NUREG-0130

**for Facility License Amendment
for Extension of Operation
With Once-through Cooling**

INDIAN POINT UNIT NO. 2

FINAL ENVIRONMENTAL STATEMENT
by the
U. S. NUCLEAR REGULATORY COMMISSION
OFFICE OF NUCLEAR REACTOR REGULATION
FOR
FOR FACILITY LICENSE AMENDMENT
FOR
EXTENSION OF OPERATION WITH
ONCE-THROUGH COOLING FOR
INDIAN POINT UNIT NO. 2

Fig. 3-1. Curves for relative yield versus time. The three curves are for cessation of once-through cooling at Indian Point Unit No. 2 on May 1, 1979 (solid line) and on May 1, 1981 (dashed line) and for the base design of once-through cooling for 35 years at both Unit Nos. 2 and 3 (dotted line).

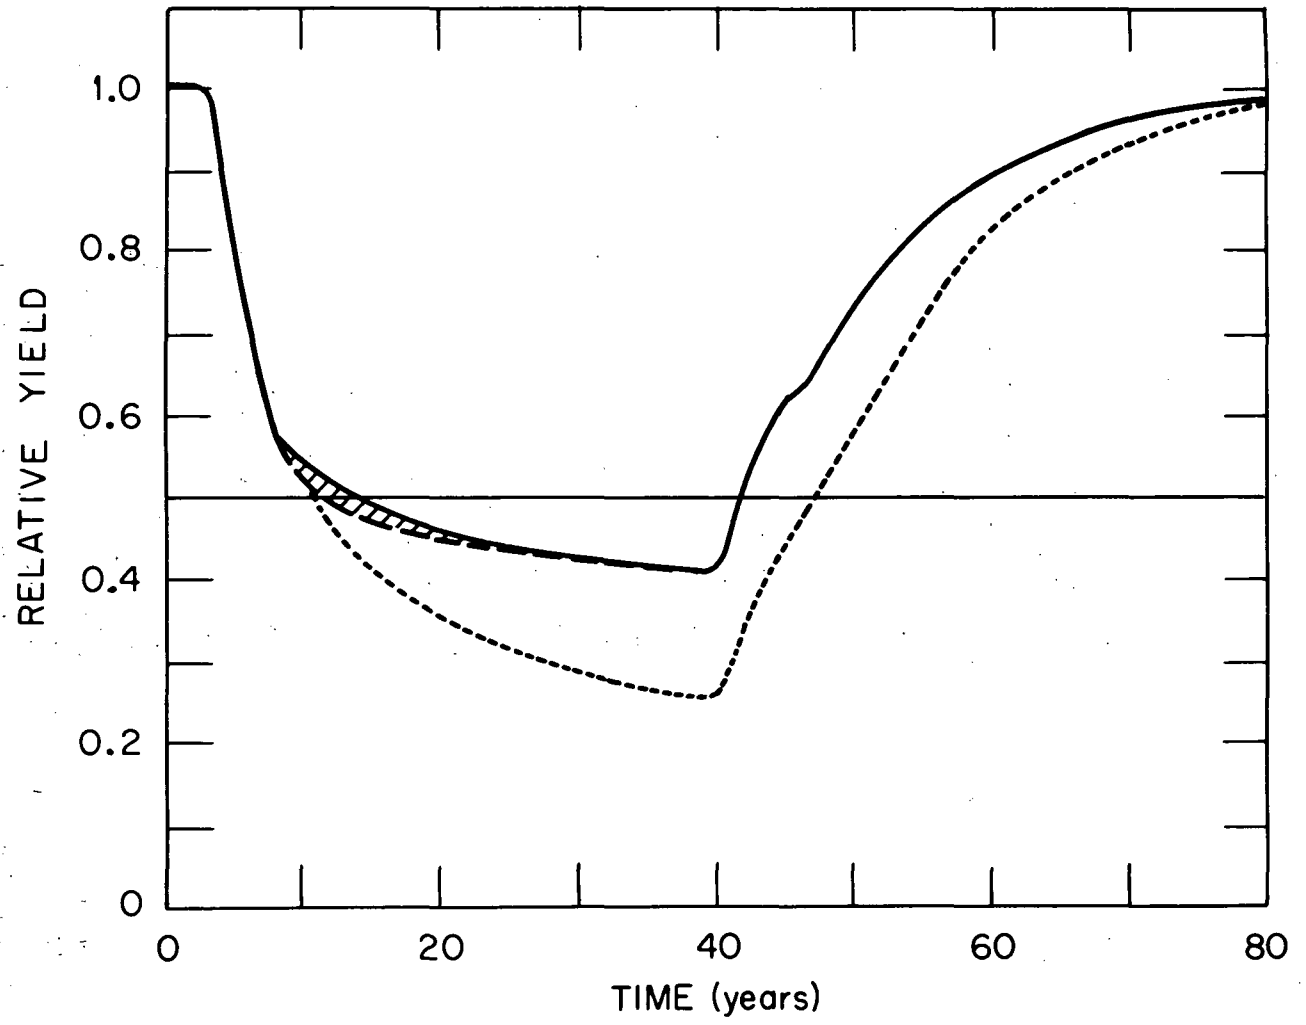
The West Branch Conservation Association comments concerning Fig. 3-1 of the present RES (i.e., Relative Yield versus Years) "that even after cessation of once-through cooling the decline will continue." Such a time delay of three years between cessation of the power plant impact and an increase in yield to the fishery is exactly what would be expected (in fact, required) of any such life-cycle population model. Note that there is a similar three-year time delay between the initiation of power plant impact at year 0 and decrease in yield to the fishery. Both of these time delays occur because the power plants effect the zero age class, whereas fish are not recruited into the fishery until they are three-year olds. These time delays do not, in and of themselves, have any bearing on the question of irreversibility.

Table 1. Comparison of probability of survival from post-sac larvae to juveniles for 1973 and 1974^a

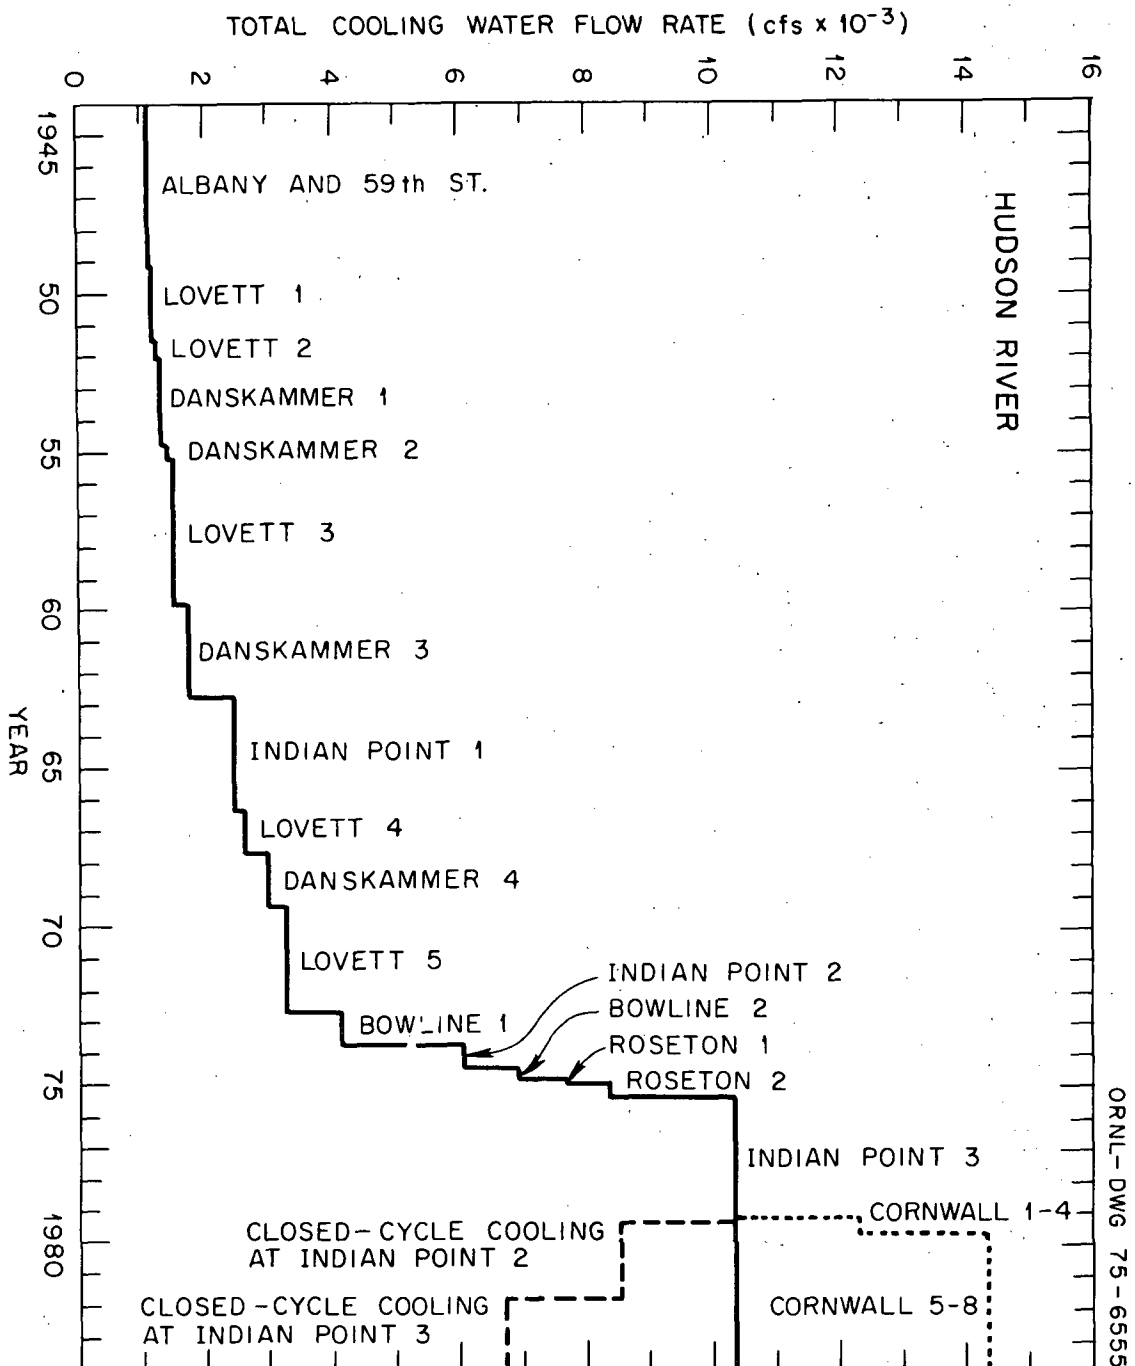
The first comment of the West Branch Conservation Association suggests a lack of appreciation for the magnitude of natural, annual variations in year-class strength for a fish population such as the striped bass. For example, indices of year-class abundance for striped bass from 1965 through 1974 (less 1966 and 1971) are given in the TI Multi-plant Report (Table V-3, p. V-26). These indices range from 1.7 (1968) to 78.8 (1973), i.e., a ratio of minimum to maximum of 0.022. The value for 1973 is the highest for any of these years, although the volume of water withdrawn by the power plants on the Hudson River during the entrainment season was considerably greater in 1973 than in any preceding year (Fig. A-1). Of course, what is lacking for each year except 1973 and 1974 are river-wide estimates of total standing crop of post yolk-sac larvae. Without this information it is not possible to estimate survival from post yolk-sac larvae to juveniles in August, which is really the issue at stake here.

A closer look at the 1973 and 1974 data in Appendix B indicates that the difference between 1973 and 1974 is even more pronounced than suggested by the comment of the West Branch Conservation Association. As indicated in Table 1 the survivability in 1974 between post
